ENERGY NORTHWEST

November 29, 2000
GO2-00-197

Subject: **WNP-2, OPERATING LICENSE NPF-21
INSERVICE INSPECTION PROGRAM PLAN
RELIEF REQUESTS 2ISI-21 THROUGH 2ISI-24**

**INSERVICE INSPECTION PROGRAM PLAN
RELIEF REQUESTS 2ISI-21 THROUGH 2ISI-24
Page 2 of 2**

Figure 2ISI-24-1

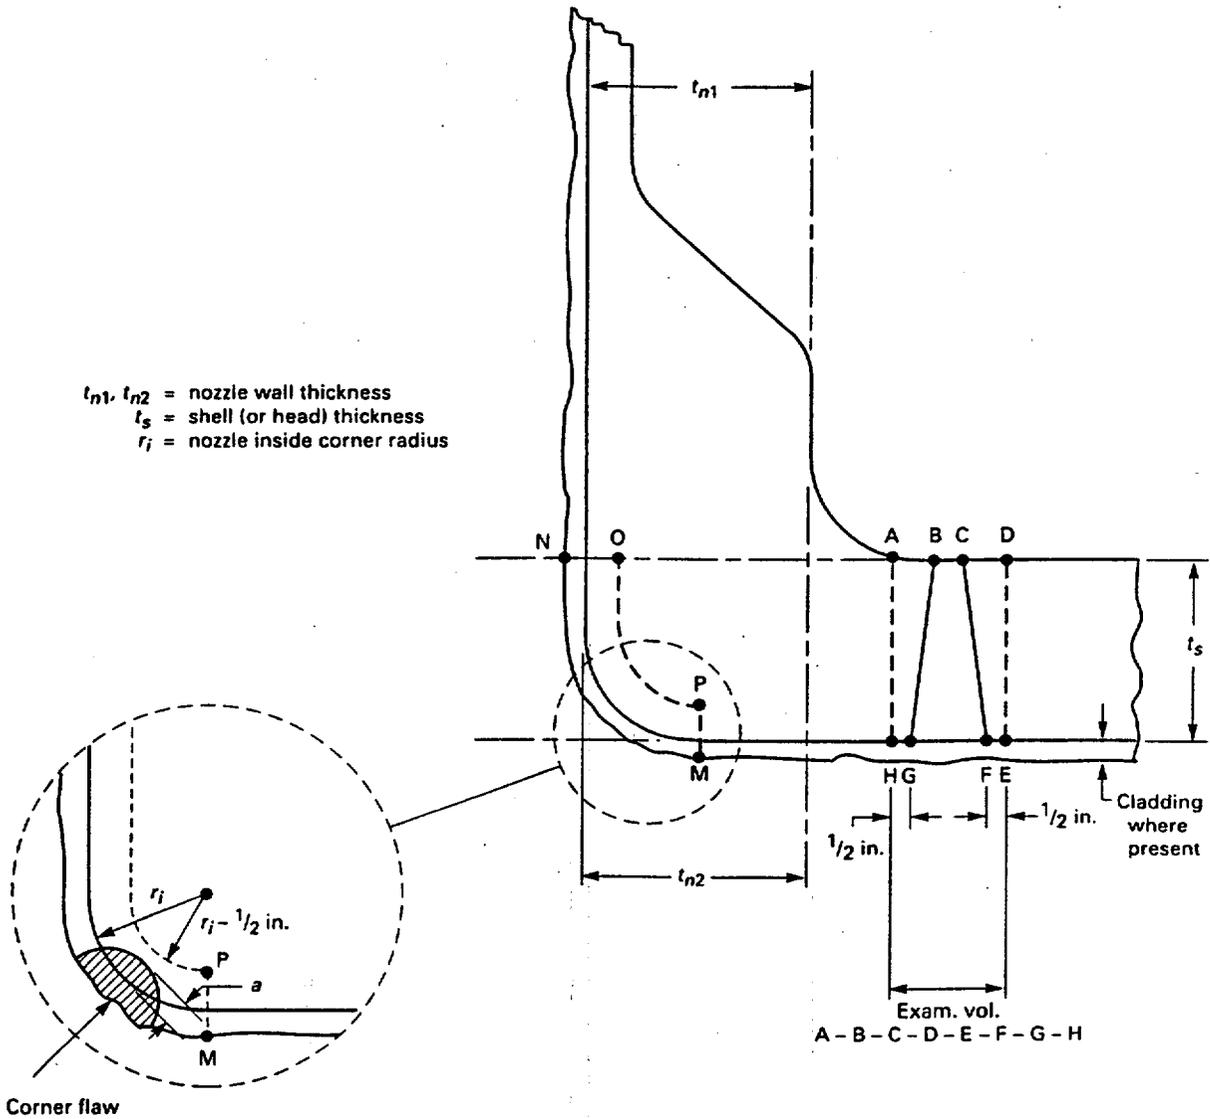
The current examination volume for the Reactor Vessel pressure retaining nozzle-to-vessel welds includes base metal far beyond the weld. The new examination volume reduces the base metal volume that will be examined. This removed base metal volume has been extensively examined during manufacture, preservice inspection, and inservice inspection. All these previous examinations have shown that this volume is free from flaws. It is unlikely that a new flaw will develop in this volume due to the low stresses in the base metal away from the weld.

The new examination volume, as shown in Figure 2ISI-24-1, defines a volume that includes the weld and heat affected zone. Inservice flaws are most likely to develop in this volume, since stresses caused by welding are concentrated at or near the weld.

Perform examinations in accordance with Figure 2ISI-24-1 and ASME Code, Section XI, Division 1, 1995 Edition, 1996 Addenda, Appendix VIII, as required by 10CFR50.55a.
